**SECTION 4.55 (1A) MODIFICATION APPLICATION – STATE SIGNIFICANT DEVELOPMENT APPLICATION  
6952  
WENONA SCHOOL**

This Section 4.55(1A) is submitted to the NSW Department of Planning and Environment on behalf of Wenona School Limited pursuant to Section 4.55(1A) of the *Environmental Planning and Assessment Act 1979* (EP&A Act) to modify Development Consent SSD 6952 which relates to the approval of the educational facility at Wenona School, North Sydney.

This application relates to the proposed location of the kiosk substation and associated tree removal to facilitate its repositioning. The modifications are a direct response to in-depth discussions with Ausgrid and North Sydney Council (Council) regarding the location of the substation. During these discussions, it was determined that the amendments are necessary to mitigate the potential conflicts between the tree and the kiosk substation. It is noted that the proposed modifications do not amend the approved building, nor will they result in any additional environmental impacts.

**Figure 1** Approved location of the kiosk substation in relation to the tree

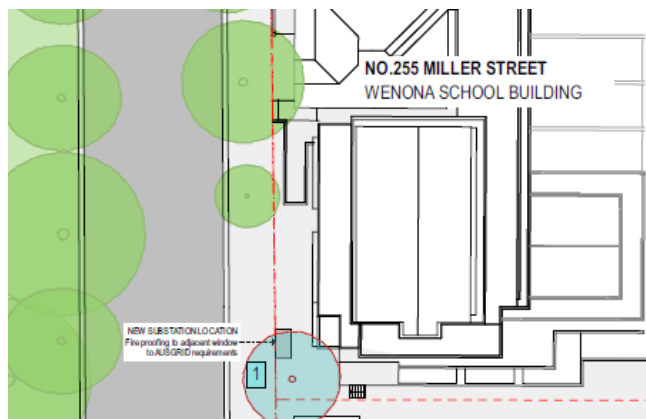
- the required relocation of the approved kiosk substation 2.25m from the site's southern boundary;
- excavation works including the addition of supporting piers to a depth of 1860mm to 1980mm and earth rods with a depth of 5.4m to facilitate the installation of the kiosk substation;
- removal of the *Lophostemon Confertus* located to the south of the substation; and
- inclusion of a *Tristaniopsis Laurina* adjacent the substation.

The proposed tree removal relates to a *Lophostemon Confertus* located at the southern end of the Miller Street frontage. The tree is required to be removed due to its proximity to the proposed kiosk substation. The location of the tree is illustrated below in **Figures 1** and **2**. As shown below, the tree is one of many located along the street frontage.

**Figure 3** Proposed location of the replacement tree planting

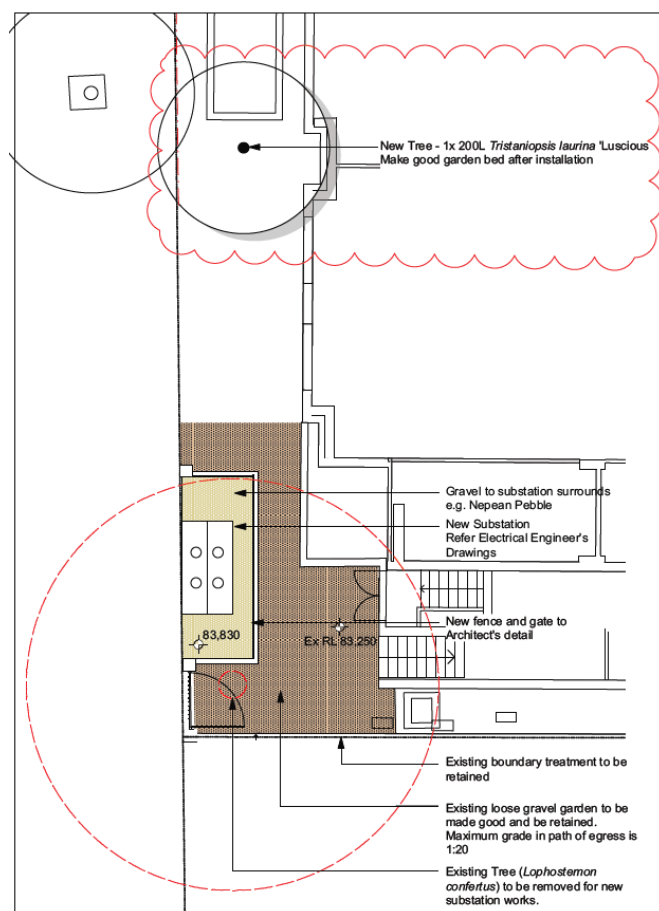
To offset the removal of the tree, a *Tristanopsis Laurina* is proposed to be along the Miller Street frontage. The tree will reach an approximate height of 6m in height (refer to **Figure 3**). The tree planting will be accompanied by make-good works to the garden bed. The species of tree has been selected on the basis that it is consistent with Council's *Street Tree Strategy* and its root structure and size will not come into conflict with existing services of the adjacent building.

**Figure 4 Kiosk substation along Miller Street**

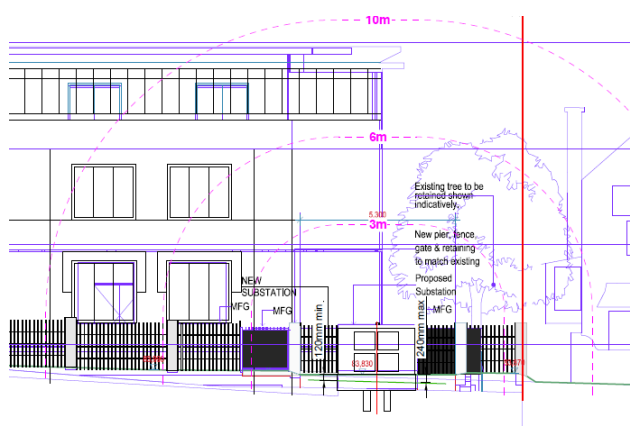
The kiosk substation has a height of 1.2m and will be screened by its own perimeter fencing (refer to **Attachment A** and **Figure 4**). The substation requires the establishment of an easement that corresponds with its size and is proposed to be 5.3m in length and 2.05m in width (refer to **Figure 5**). The easement will be established on Lot 8 of DP 996381. The details of the substation, along with the excavation works required to facilitate its installation, are provided in the Electrical Services Report prepared by Connect Infrastructure at **Attachment C**.
